**ADDENDUM NO. 1
NEW ELEVATOR
AT MURPHY ELEMENTARY SCHOOL
ROUND LAKE SCHOOL DISTRICT NO. 116
PROJECT NO. 23170**

Board of Education
Round Lake School District 116
884 West Nippersink Road
Round Lake, Illinois 60073

HV1.0

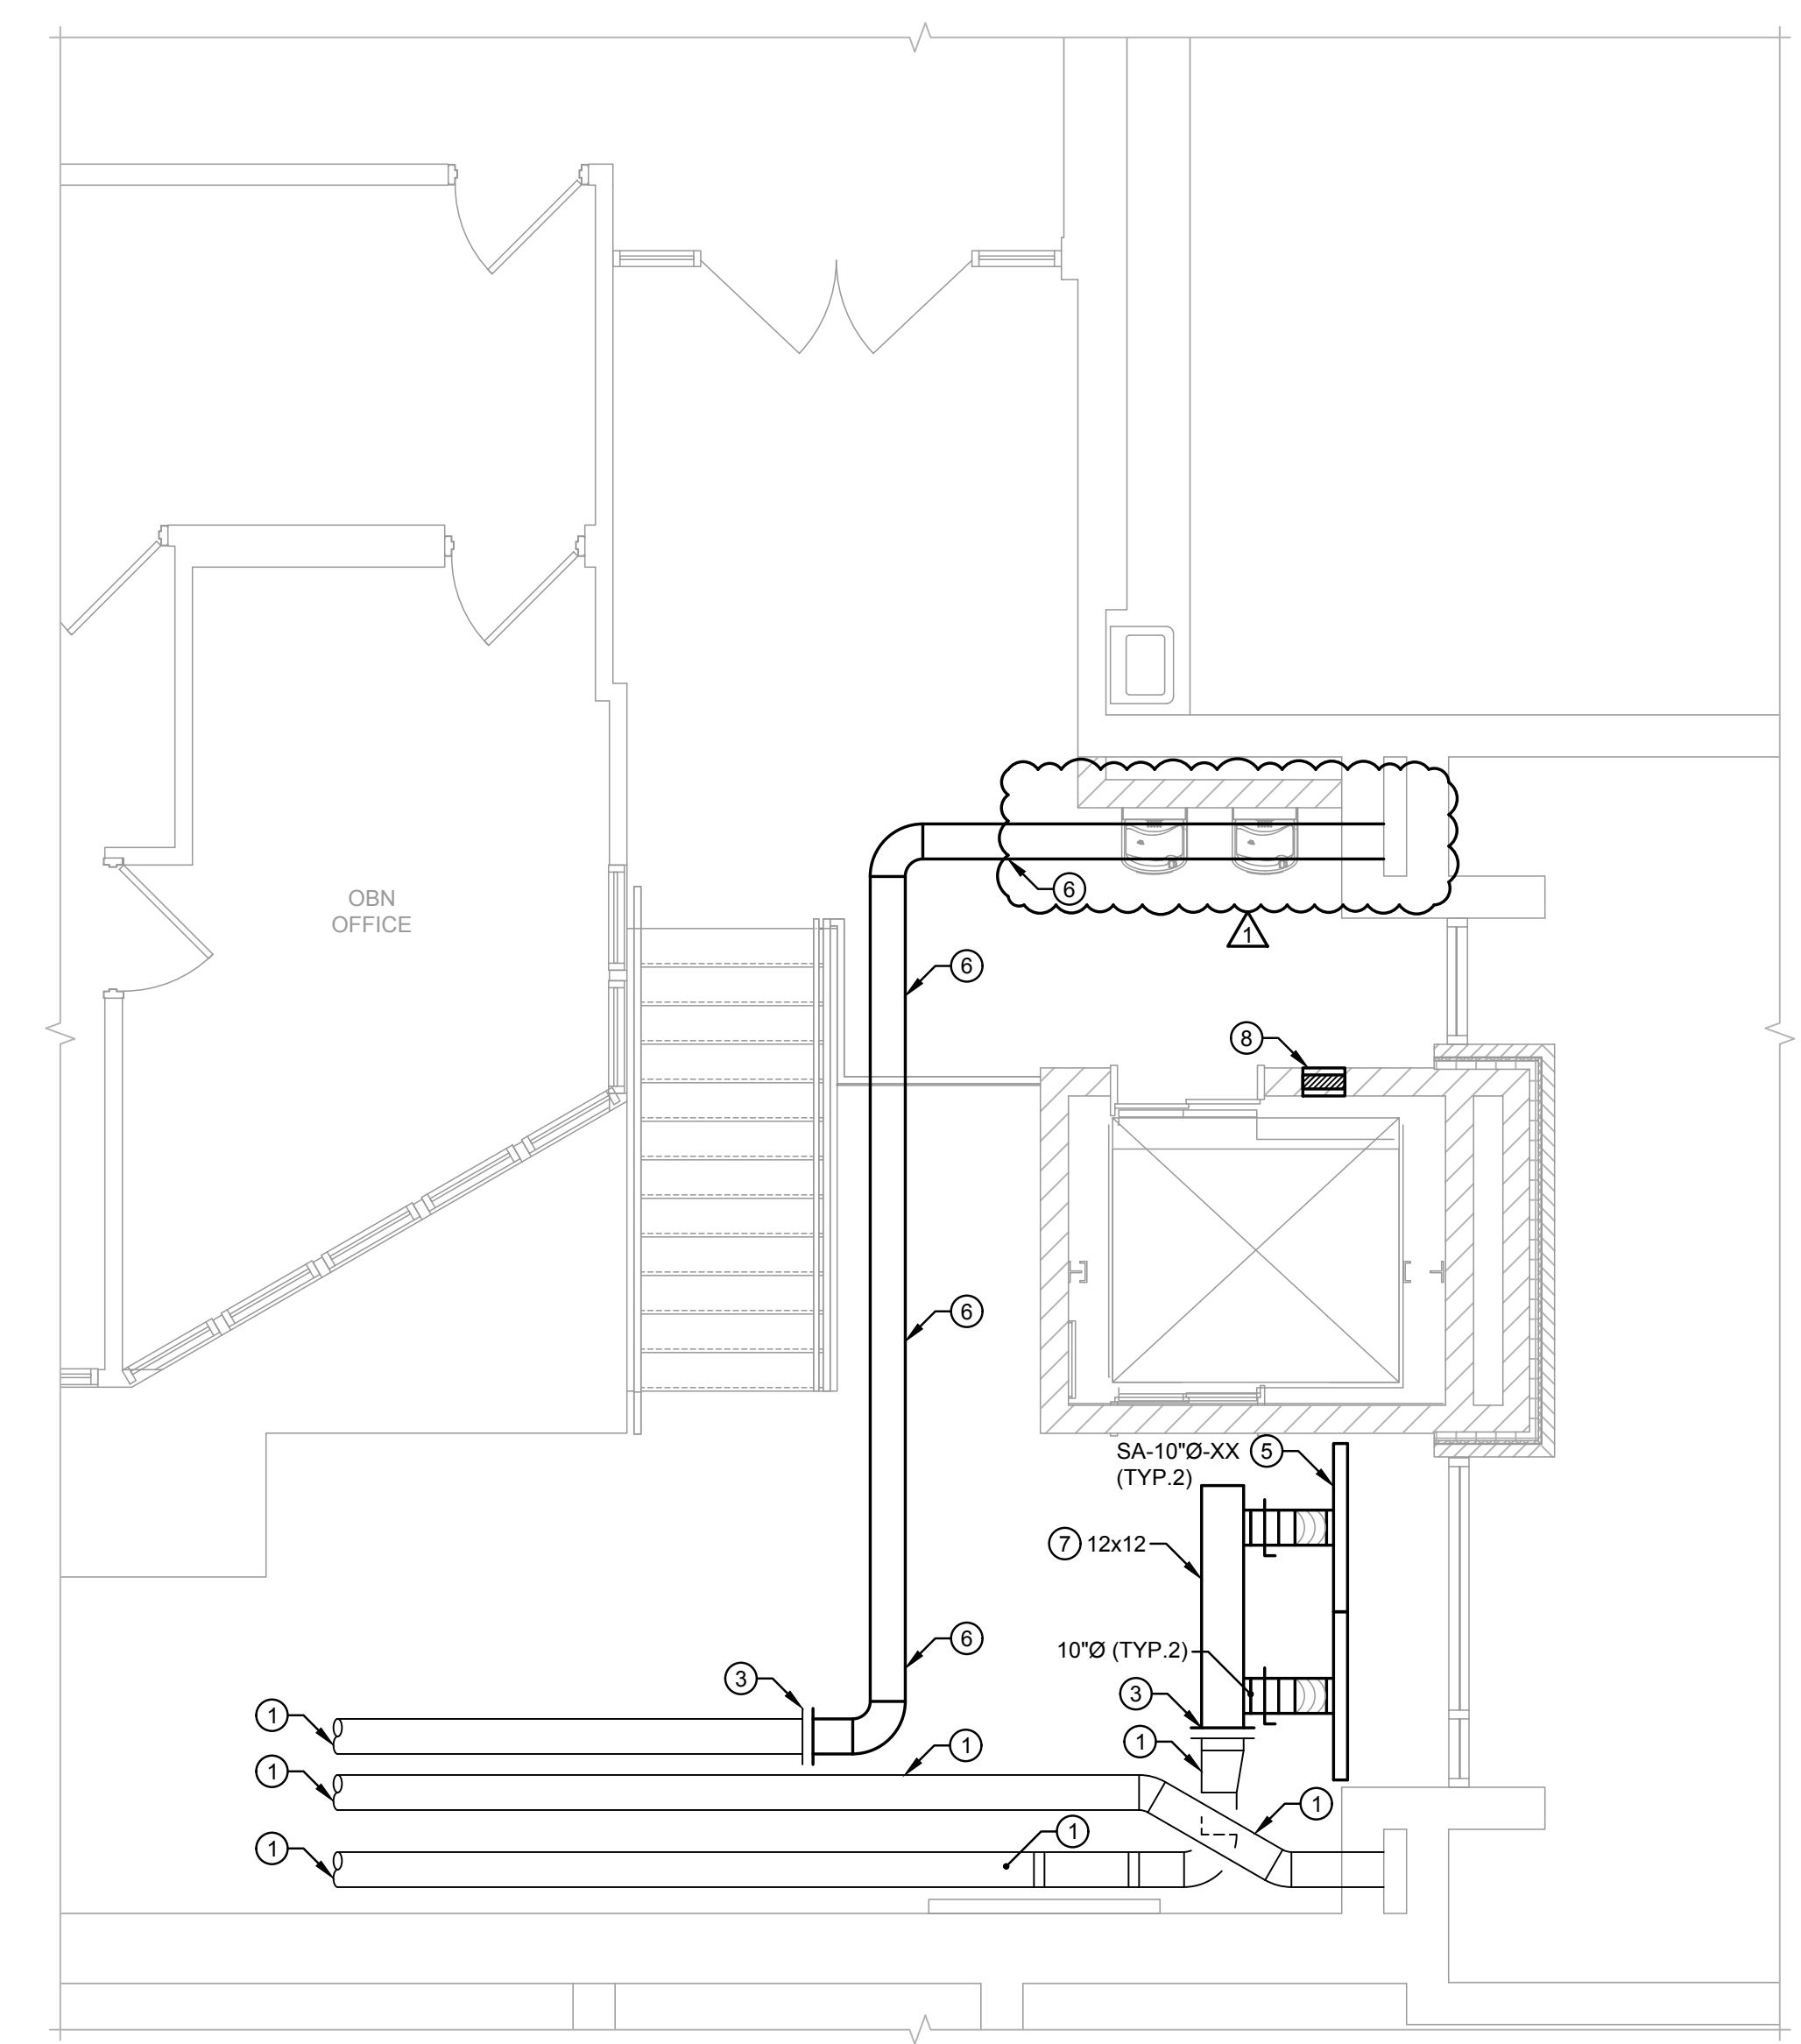
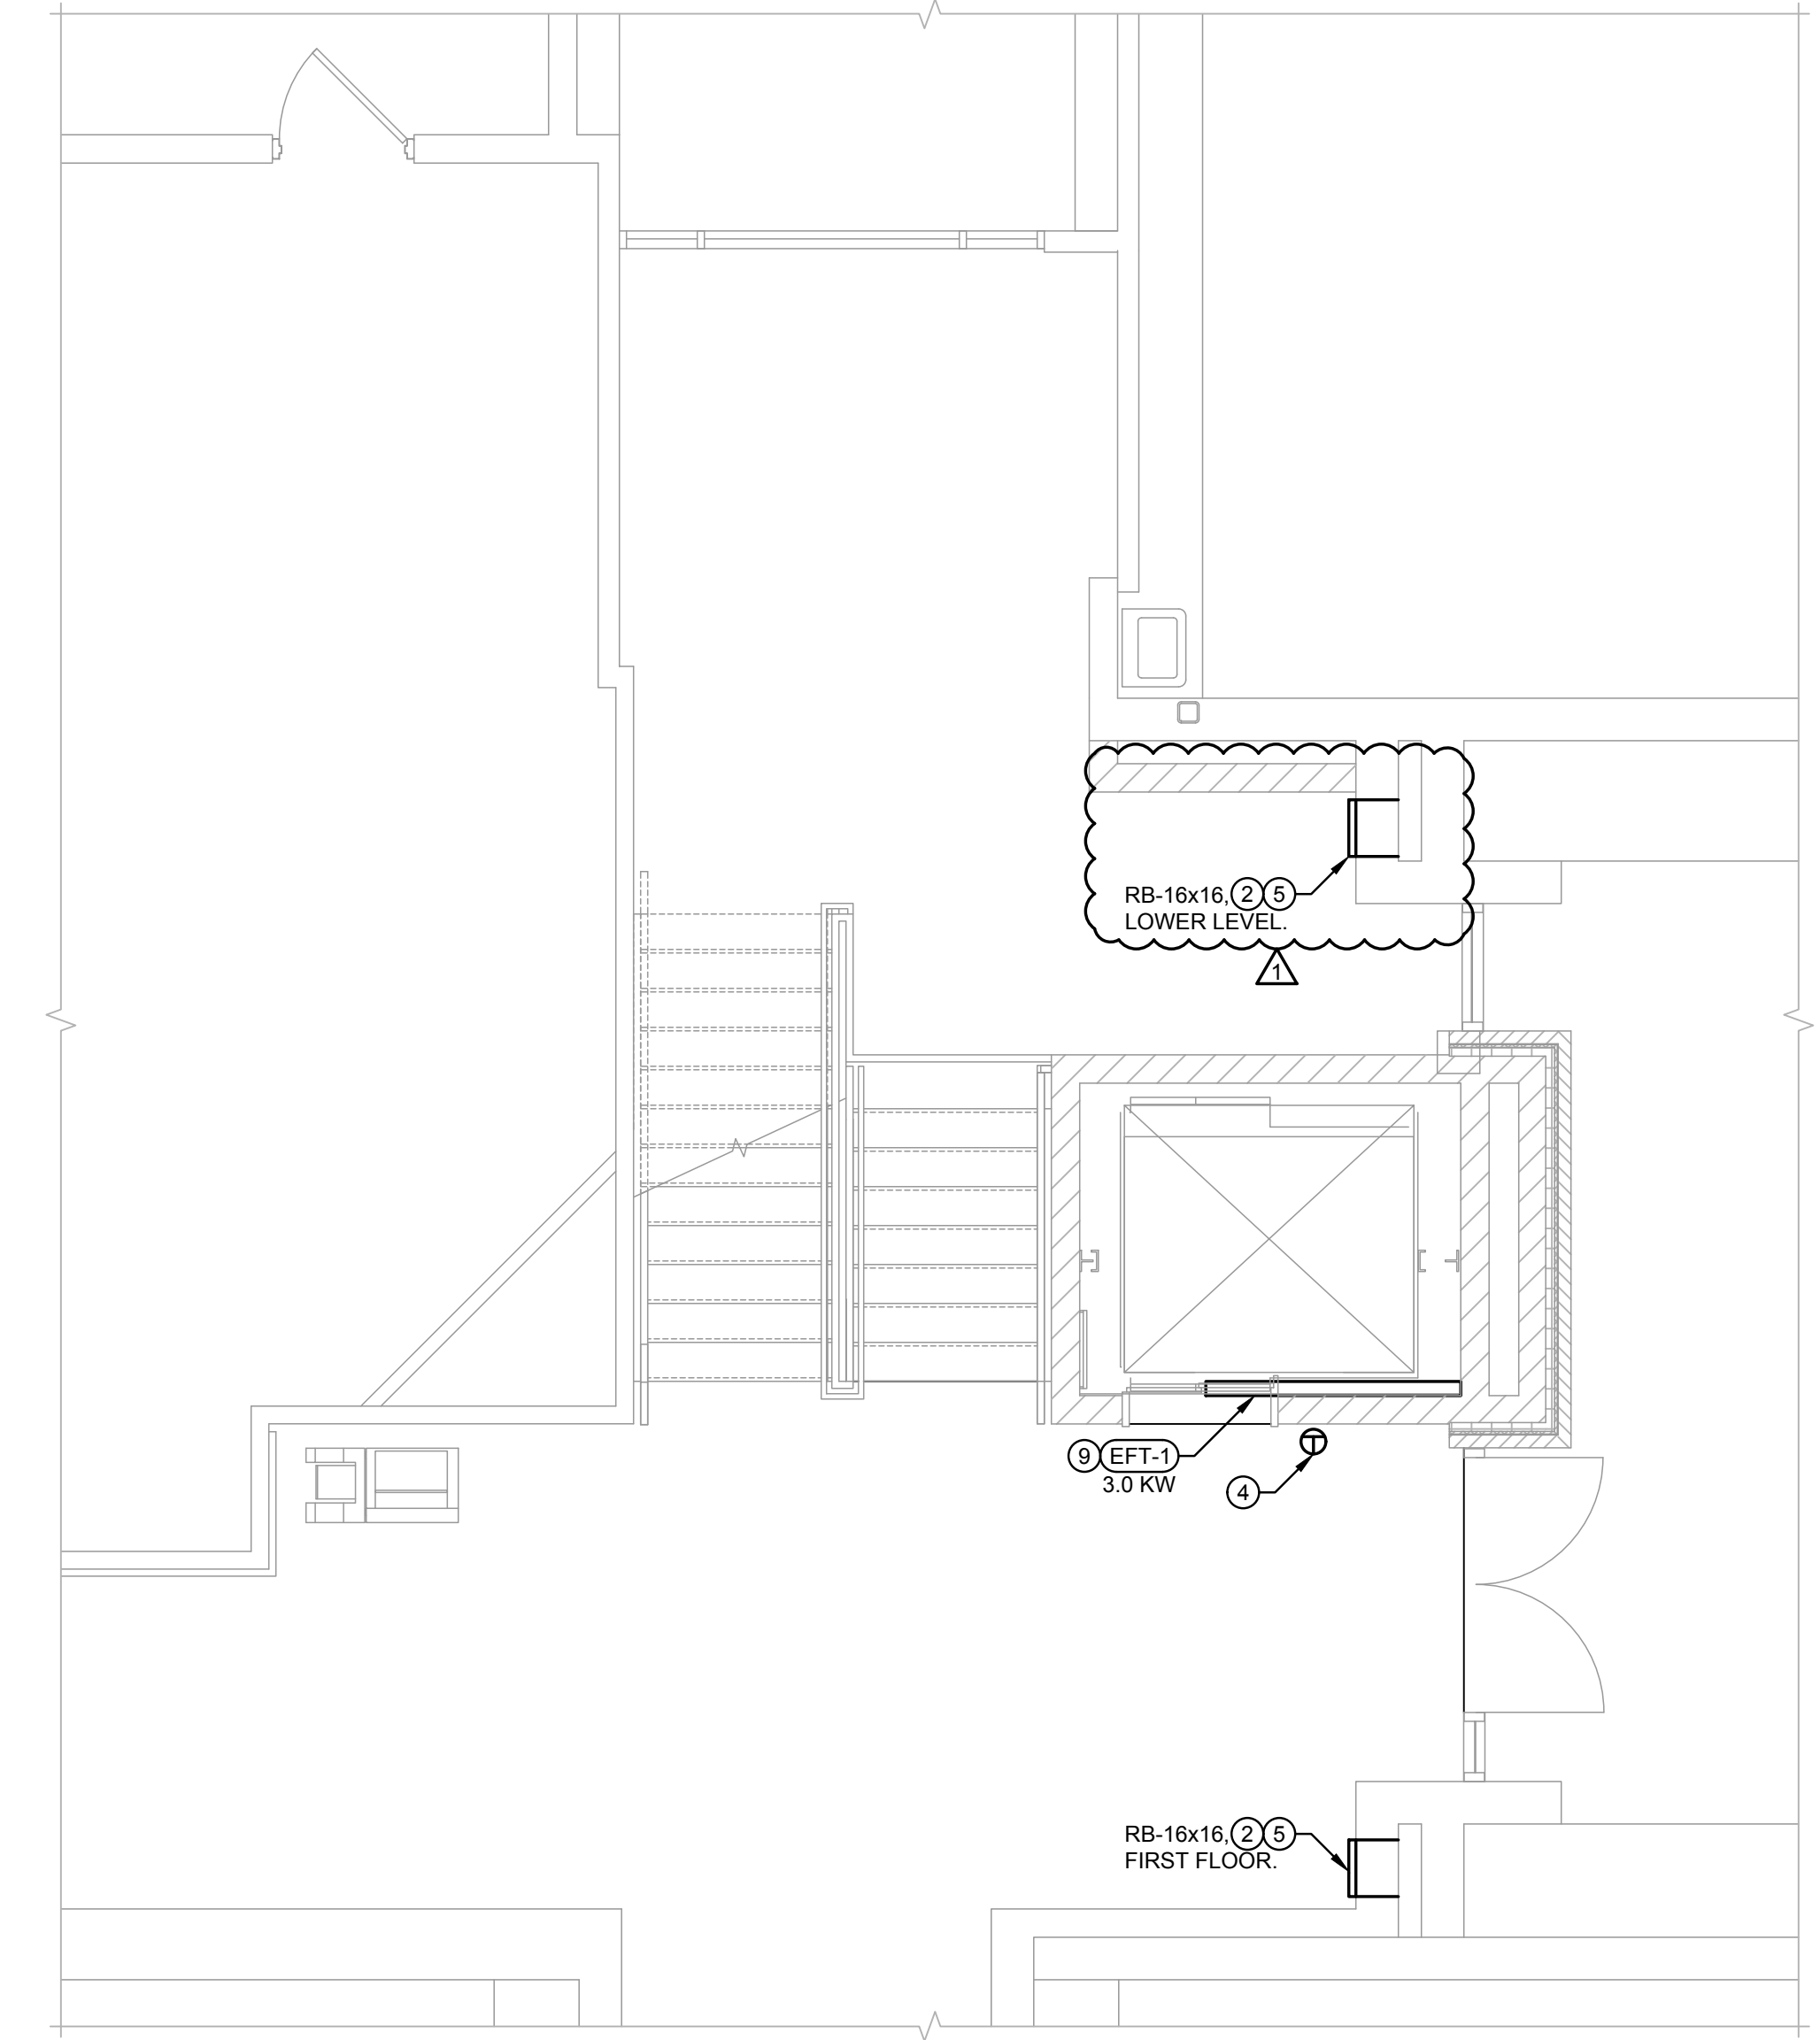
ITEM NO. 7: PROJECT DRAWINGS, HV1.0, PARTIAL HVAC PLANS

1. Refer to attached drawing HV1.0 and refer to highlighted items for updates.
